*2nd Preliminary Consultation*  
**MONTGOMERY COUNTY HISTORIC PRESERVATION COMMISSION**  
**STAFF REPORT**

<b>Address:</b>	3914 Washington Street, Kensington	<b>Meeting Date:</b>	5/27/2020
<b>Resource:</b>	Primary-Two (Contributing) Resource <b>Kensington Historic District</b>	<b>Report Date:</b>	5/20/2020
<b>Applicant:</b>	Karin Tetzlaff Averbeck	<b>Public Notice:</b>	5/13/2020
<b>Review:</b>	2 <sup>nd</sup> Preliminary Review	<b>Staff:</b>	Dan Bruechert
<b>Proposal:</b>	Building addition, dormer alteration, porch restoration, and accessory structure

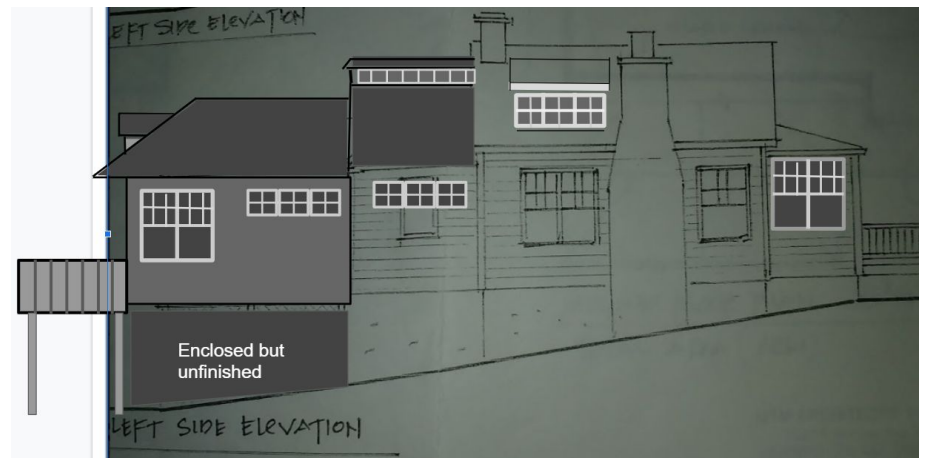
RECOMMENDATION	RESPONSE
<p>1. Proposed 3 windows overwhelm the front gable. An enlargement of the existing vent may be possible, but measured drawings of the <b>existing condition</b> and the <b>proposed window</b> is necessary to better evaluate the proposed change.</p>	<p>Shed dormer springline below top ridge. Dormer inset from original wall below. Dormer 7' x 3' high at windows.</p> <p>Windows. Original vent is 18"x30". Replace vent with 2 windows 18" x 30".</p> <p>7 ft</p> <p>3 ft</p> <p>6.5 ft</p> <p>6.5 ft</p> <p>24 ft</p> <p>19 ft</p> <p>5 ft</p> <p>5 ft</p> <p>5 ft</p> <p>1 ft</p> <p>Windows 17x48</p> <p>Front Porch Railing</p>
<p>2. Comments regarding the side-projecting dormers were split amongst the Commissioners. Some feel that while the proposal is unusual, they are <b>set far enough back</b> from the front of the house so as not to detract. Other Commissioners</p>	<p>Shed dormer springline below top ridge. Dormer inset from original wall below. Dormer 7' x 3' high at windows.</p> <p>Windows. Original vent is 18"x30". Replace vent with 2 windows 18" x 30".</p> <p>7 ft</p> <p>3 ft</p> <p>6.5 ft</p> <p>6.5 ft</p> <p>24 ft</p> <p>19 ft</p> <p>5 ft</p> <p>5 ft</p> <p>5 ft</p> <p>1 ft</p>

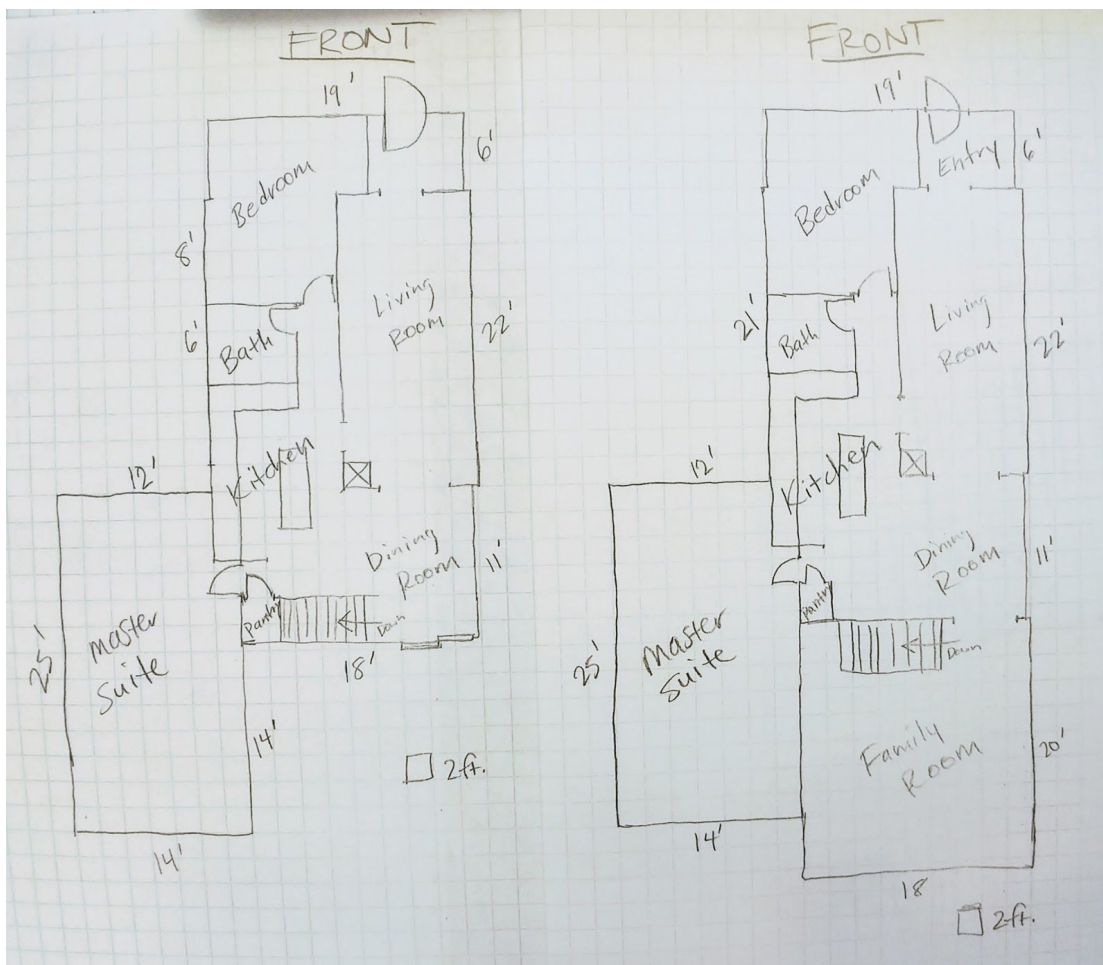
QUESTION	RESPONSE
<p>1. Commissioners had several questions regarding the proposed porch enclosure and determined that they could not make recommendations or determinations of appropriateness without this information. Many of these questions were identified in the Staff Report including:</p> <ul style="list-style-type: none"> <li>• What is the condition of the <b>historic exterior</b> wall (now interior)?</li> <li>• What is the proposed <b>framing</b> for the front porch?</li> <li>• What are the proposed <b>window dimensions</b> and materials?</li> </ul>	<ul style="list-style-type: none"> <li>• The historic exterior wall (now interior) has been completely removed on the windowed side of the house. On the front door side of the house, there is a partial wall which is drywalled (no siding present).</li> <li>• Framing: 4 posts evenly spaced across the front. 1 window and front door in the first opening, 3 windows in the 2nd and 3rd openings between the posts. Headers and sill plates span between posts.</li> </ul> <p>Similar examples:</p> <div data-bbox="584 573 870 953"> </div> <div data-bbox="907 573 1243 825"> </div> <div data-bbox="1276 567 1373 861"> </div>

<p>2. Other Commissioners expressed concern that an all-glass front porch was not a compatible feature on a front elevation and questioned the ability to install an additional sash window on the front elevation.</p>	<div data-bbox="584 963 1341 1341"> </div> <ul style="list-style-type: none"> <li>• <b>Window dimensions: 17x48</b>  <b>Materials - Wood, vinyl clad</b>  <b>Pella Architect or Anderson 400</b>  <a href="https://www.andersenwindows.com/ideas-and-inspiration/design-tool/400-series-casement-window/?widIn=17&amp;hgtIn=48&amp;frameColor=Interior%3b+color%3dPine&amp;glass=Low-E4%2c%ae+Glass&amp;hardware=Traditional+Folding%3b+color%3dOil+Rubbed+Bronze&amp;grilleStyle=Colonial&amp;grilleWidth=1%22&amp;grilleSpacing=Custom...&amp;grilleLightsWide=2&amp;grilleLightsHigh=4&amp;frameColorExt=Exterior+Window+Color%3b+color%3dWhite&amp;exteriorTrim=None&amp;side=Interior">https://www.andersenwindows.com/ideas-and-inspiration/design-tool/400-series-casement-window/?widIn=17&amp;hgtIn=48&amp;frameColor=Interior%3b+color%3dPine&amp;glass=Low-E4%2c%ae+Glass&amp;hardware=Traditional+Folding%3b+color%3dOil+Rubbed+Bronze&amp;grilleStyle=Colonial&amp;grilleWidth=1%22&amp;grilleSpacing=Custom...&amp;grilleLightsWide=2&amp;grilleLightsHigh=4&amp;frameColorExt=Exterior+Window+Color%3b+color%3dWhite&amp;exteriorTrim=None&amp;side=Interior</a> </li> </ul>

**Side elevation: Shed Dormer window set dimensions 6 x 2 ft.  
3 windows each 2x2 ft**

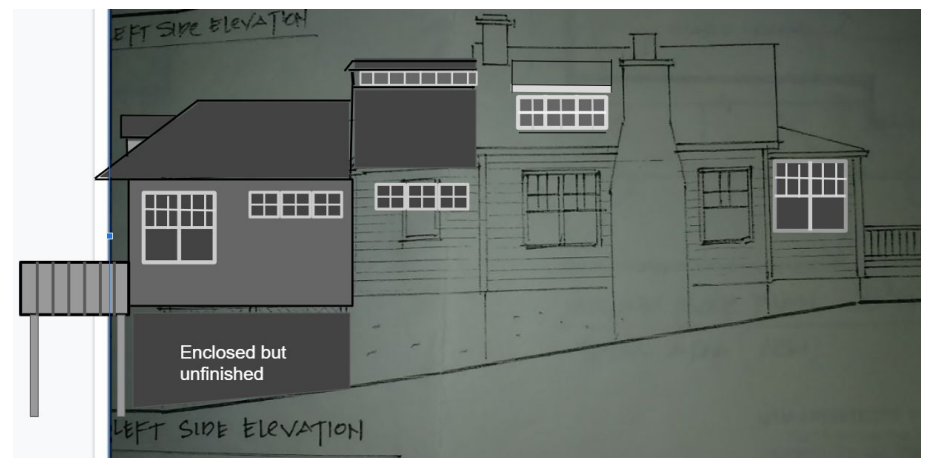
determined that the dormers would be visible from oblique views and detracted from the simple front gable bungalow house form. Another Commissioner recommended a **shed dormer** on this elevation that wouldn't stand quite so tall and could provide a bank of windows.

- a. Provide scaled measured drawings to better evaluate the proposal.

**Side elevation: Shed Dormer window set dimensions 6 x 2 ft.  
3 windows each 2x2 ft**

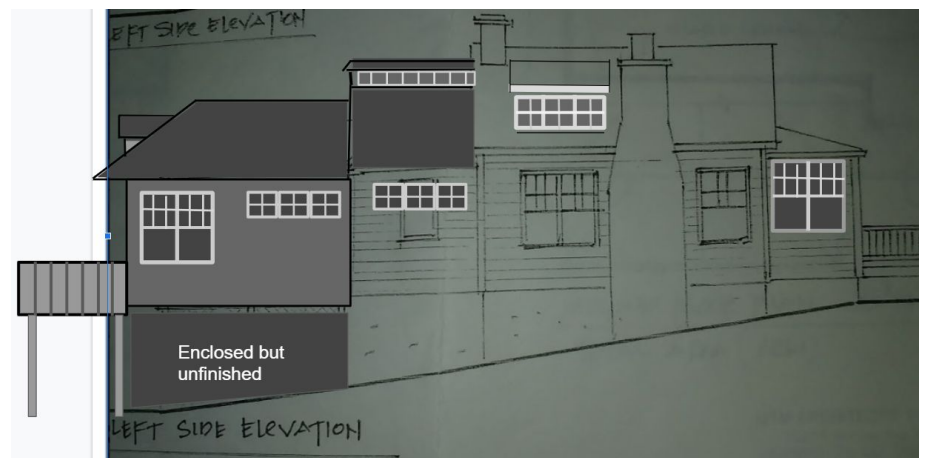
determined that the dormers would be visible from oblique views and detracted from the simple front gable bungalow house form. Another Commissioner recommended a **shed dormer** on this elevation that wouldn't stand quite so tall and could provide a bank of windows.

- a. Provide scaled measured drawings to better evaluate the proposal.

**Side elevation: Shed Dormer window set dimensions 6 x 2 ft.  
3 windows each 2x2 ft**

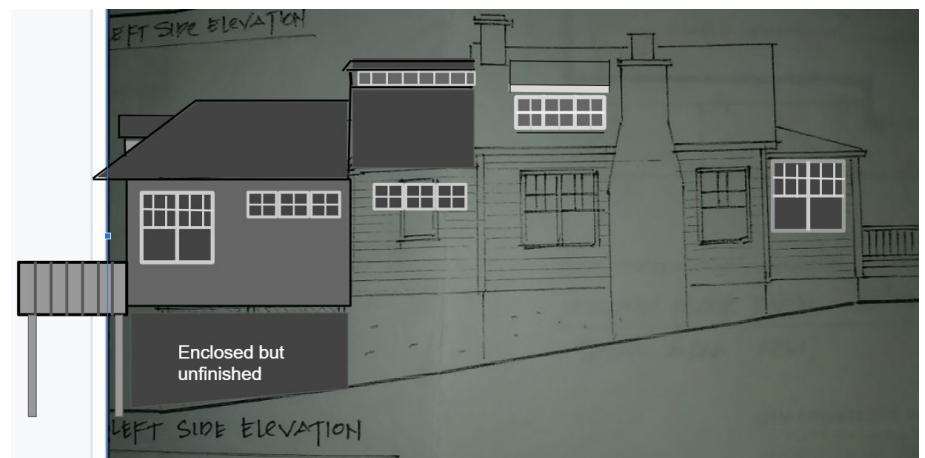
determined that the dormers would be visible from oblique views and detracted from the simple front gable bungalow house form. Another Commissioner recommended a **shed dormer** on this elevation that wouldn't stand quite so tall and could provide a bank of windows.

- a. Provide scaled measured drawings to better evaluate the proposal.
